Department of Planning and Zoning

TO: Development Review Board
FROM: Scott Gustin
DATE: November 5, 2014
RE: 15-0358CA; 82 University Place

Request: Demolish Angell Hall and Cook Physical Science Building, construct new STEM building with connecting bridge to Votey Hall.

DEPARTMENT OF PLANNING & ZONING
 OVERALL CIVIL EROSION CONTROL PLAN
 SHEET NO. C-002

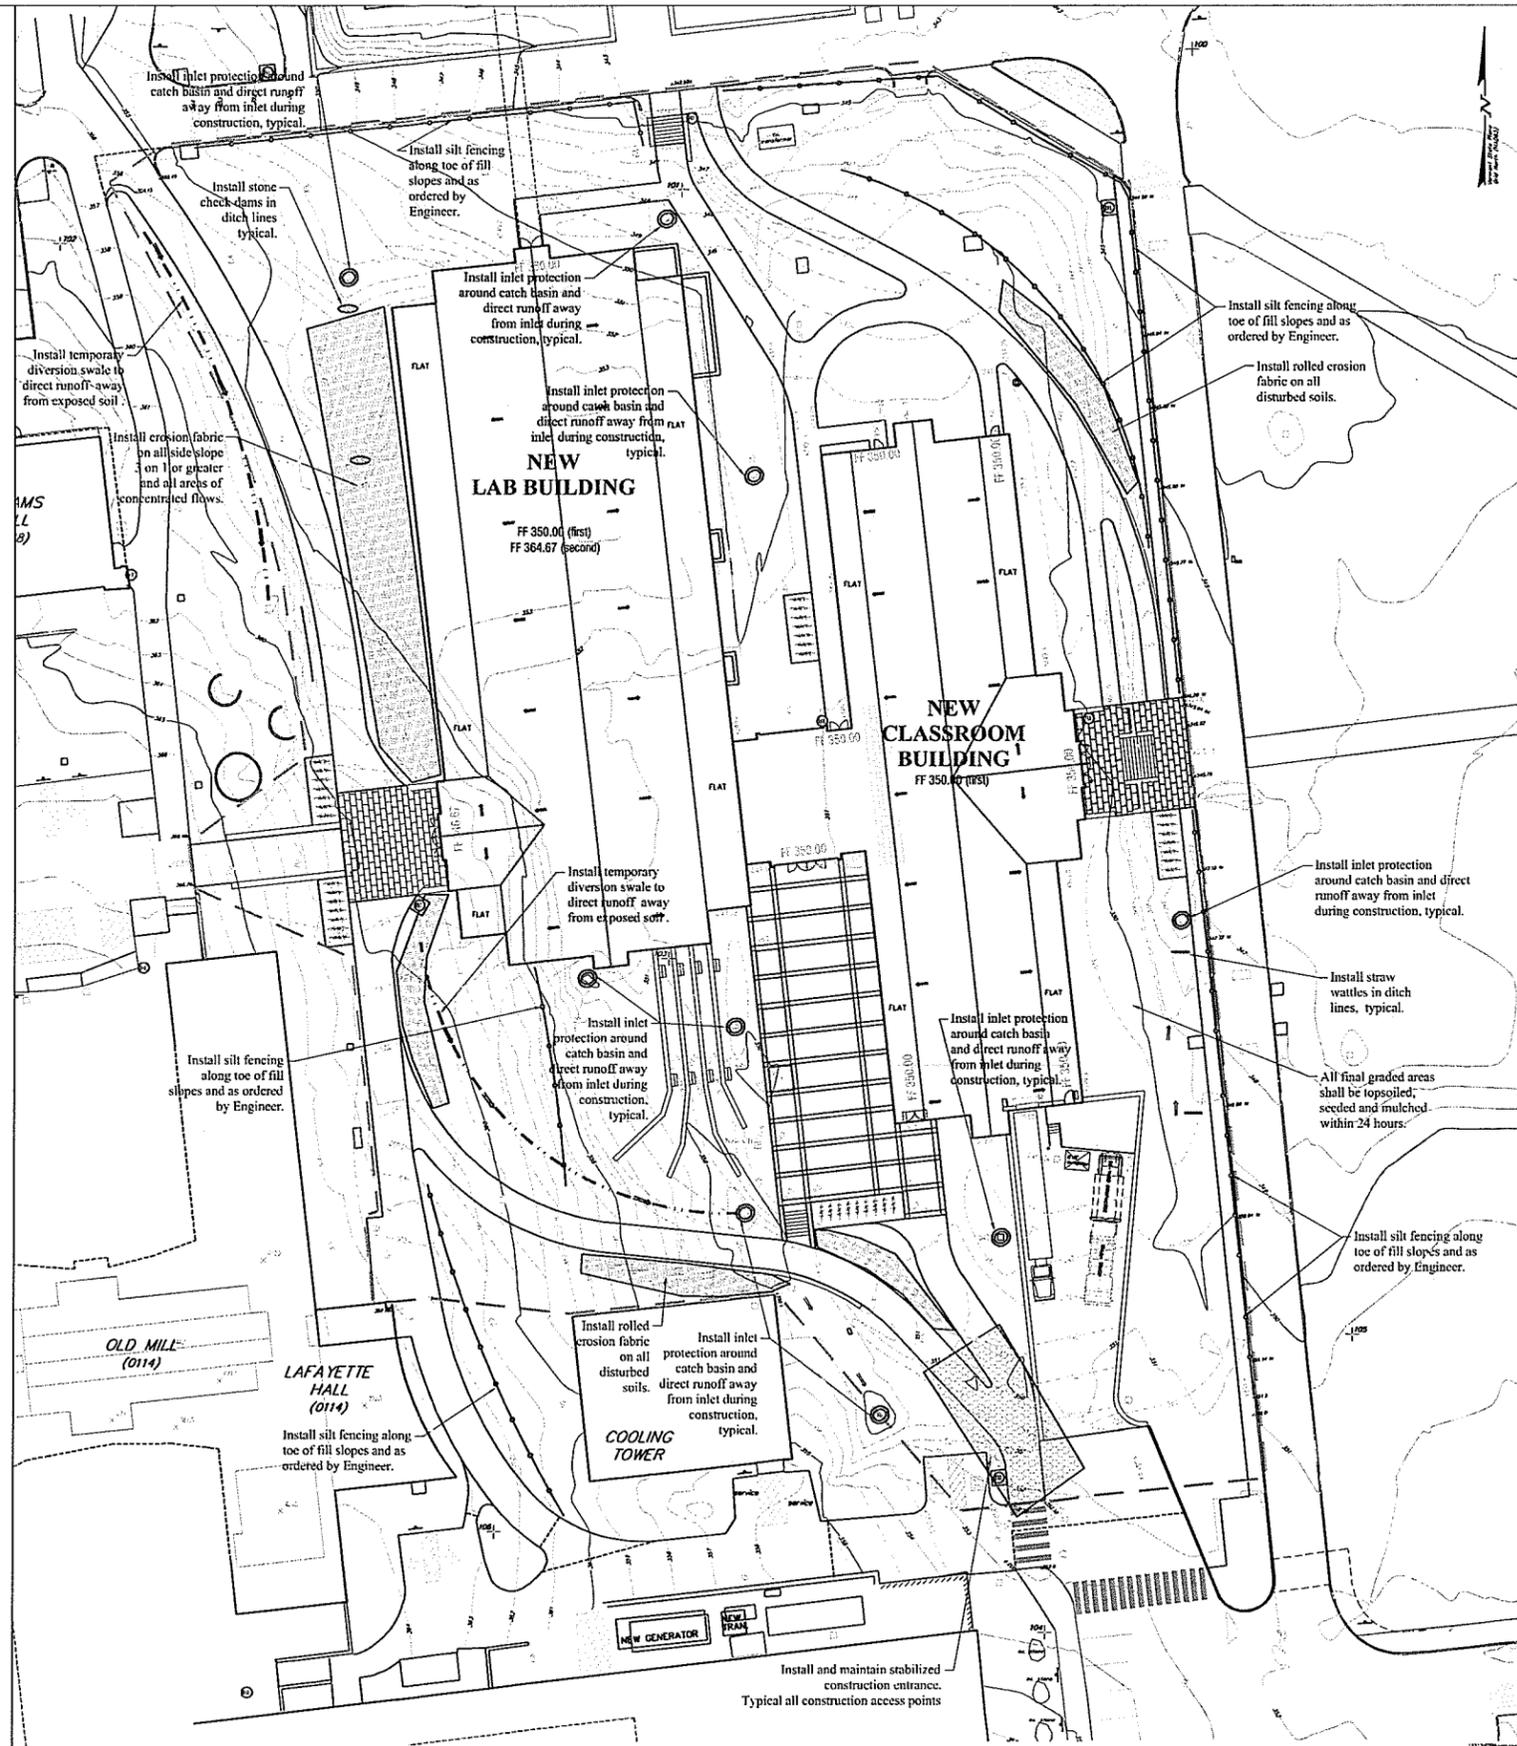
Similarly, the construction site erosion prevention and sediment control plan has been reviewed by the Conservation Board and the Stormwater Administrator. The Conservation Board recommended approval. Final approval is anticipated from the Stormwater Administrator. **(Affirmative finding as conditioned)**

2. **Prior to release of the zoning permit**, the applicant shall obtain written approval of the Erosion Prevention and Sediment Control Plan from the Stormwater Administrator.

PLANTING PLAN

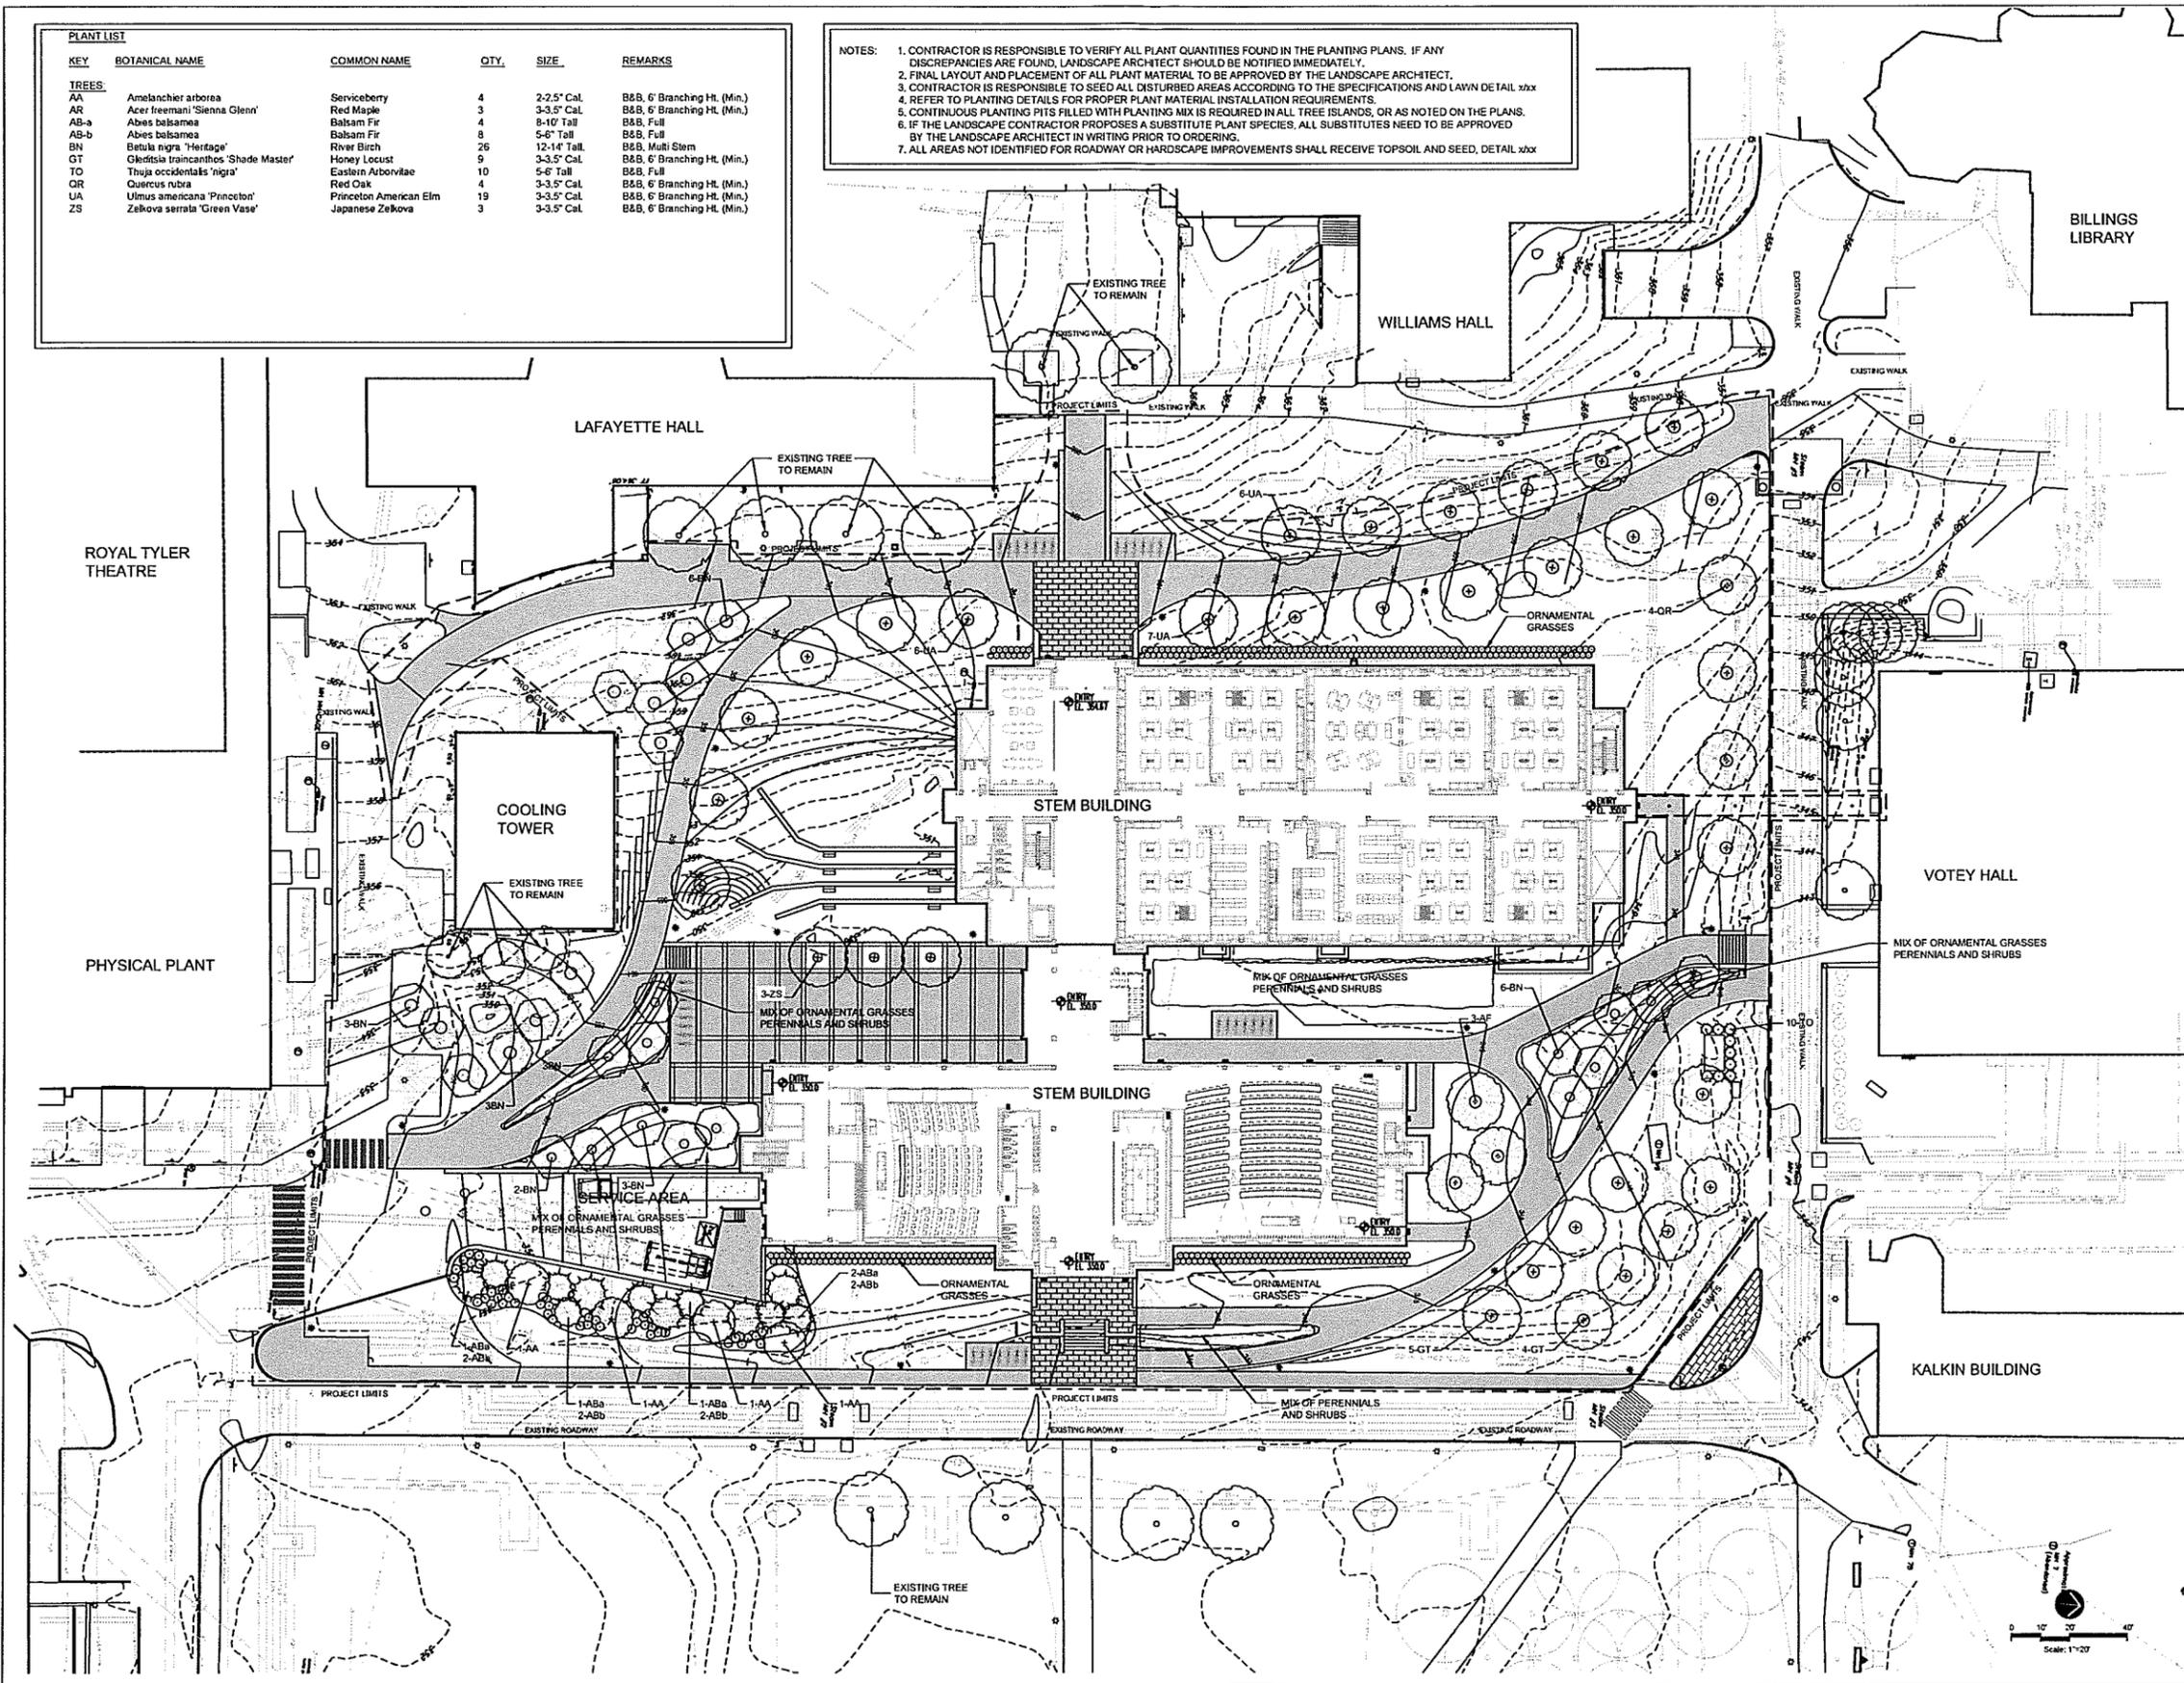
A comprehensive landscaping plan has been provided. Trees will line most of the proposed walkways. Foundation plantings will accent the eastern and western building facades. Landscaping will also be planted to screen the service bay into the building. Proposed trees consist of a variety of deciduous and evergreen species. Ornamental grasses and shrubs are also proposed.
